**Planning Board – Monday, March 22, 2021, 6:30PM**

### **AGENDA**

**S-01-21 –166 West Street – 2-Lot Subdivision** – Applicant and owner Flyboy Realty LLC proposes to subdivide the 1.03-acre parcel located at 166 West St. (TMP 576-002-000) into a 0.407-acre parcel and a 0.626-acre parcel. A waiver is requested from Development Standard 10, Lighting. This parcel is located in the Central Business Limited, Gilbo Avenue Design Overlay, and Downtown Historic Overlay districts.

**SPR-01-21 – Site Plan Review – Methadone Clinic, 152 Davis Street** – Applicant Civil & Environmental Consultants, Inc., on behalf of owner Metro Treatment of New Hampshire LP, proposes to renovate the existing 4,510 sf building located at 152 Davis St. (TMP# 583-023-000) for use as a methadone clinic and modify the existing parking lot and traffic circulation, landscaping, and exterior lighting. A waiver is requested from Development Standard 10, Lighting. The site is 0.45 acres and is located in the Commerce District.

DRAWING NO.: **C200**  
 SHEET 4 OF 10

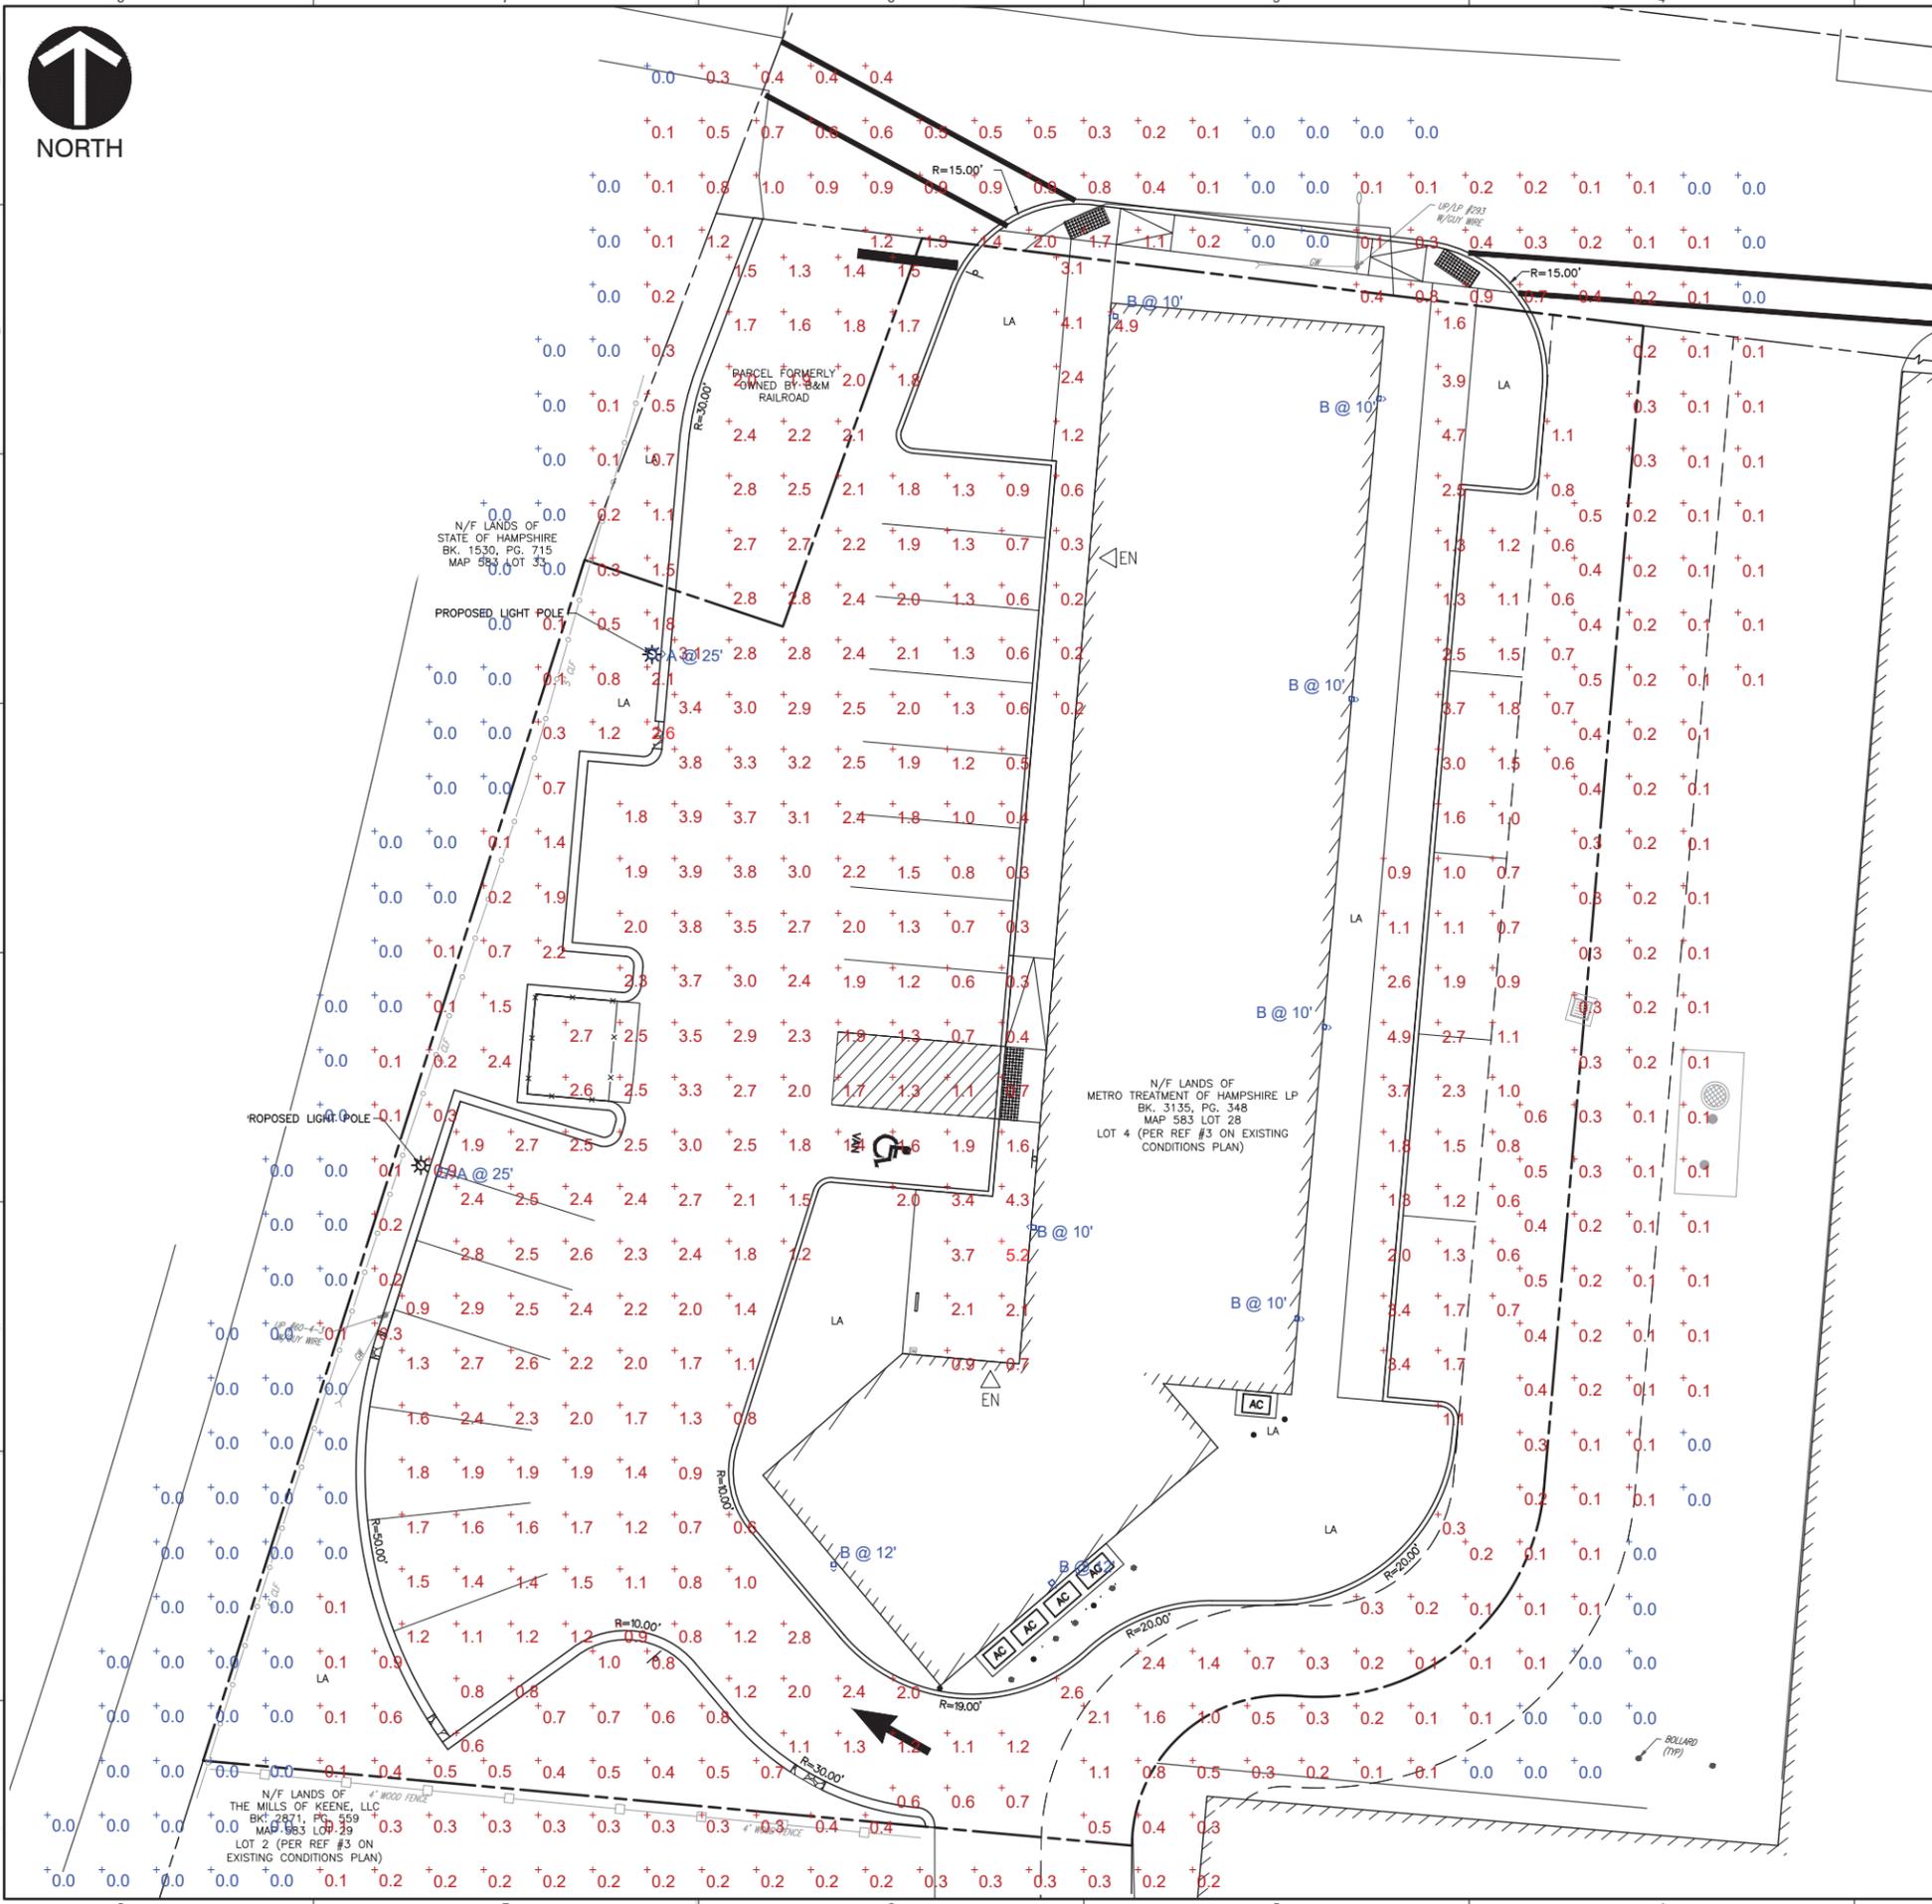
3. Hillsides: There are no steep slopes on this site. This standard does not apply.
4. Snow Storage: Note #3 on the Site Layout Plan (Sheet C200) states that "The snow shall not be plowed to the front of the driveway and if so, not higher than 2'. Any excess shall be removed and taken off site in accordance with the City of Keene code of ordinances." In addition, the site layout plan indicates that the strip of land along the west property boundary will be used for snow storage. This standard appears to be met.

RESPONSE: This is included in the “Site Development Zoning Data on sheet C200. Existing impervious surfaces = 16,008 SF, Proposed imperious surfaces 15,667 SF.
